TR-9 Open Source Digital Radio

Title: HMI Board

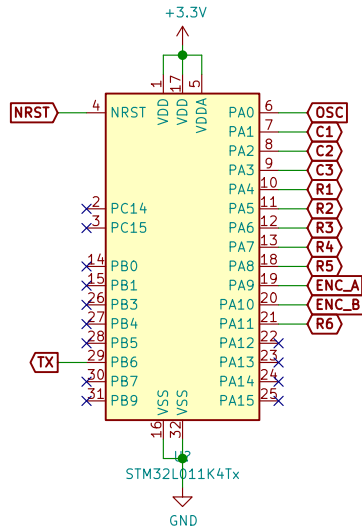
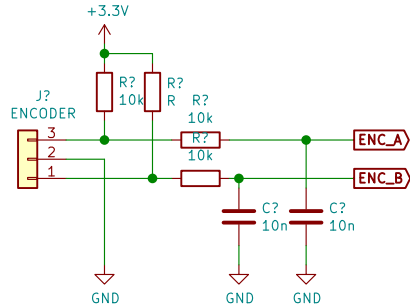
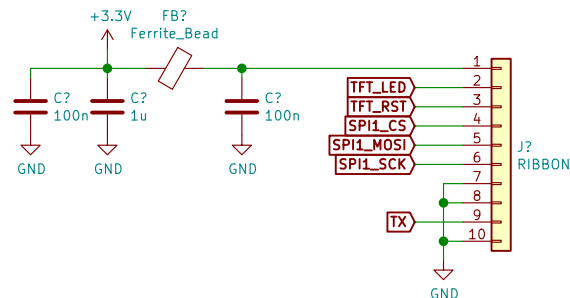
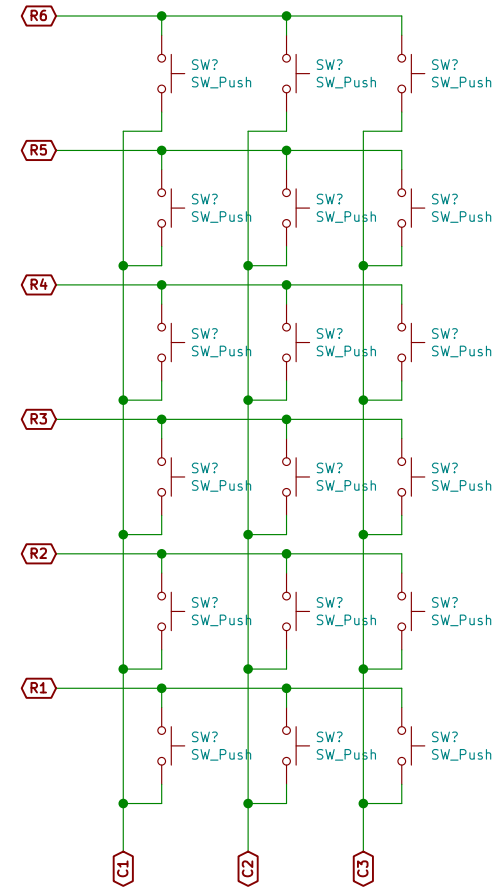
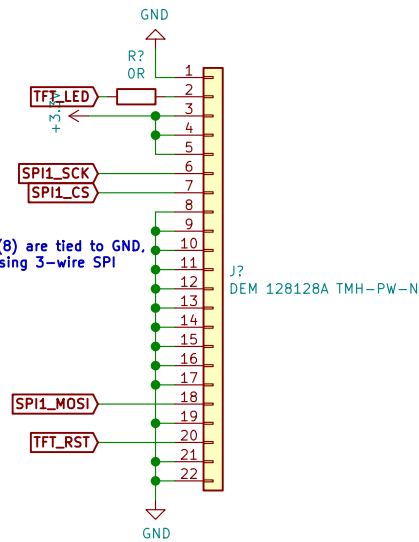
We are using a pot instead – so no longer needed

/RD (9) and /WR (8) are tied to GND, assuming we are using 3-wire SPI
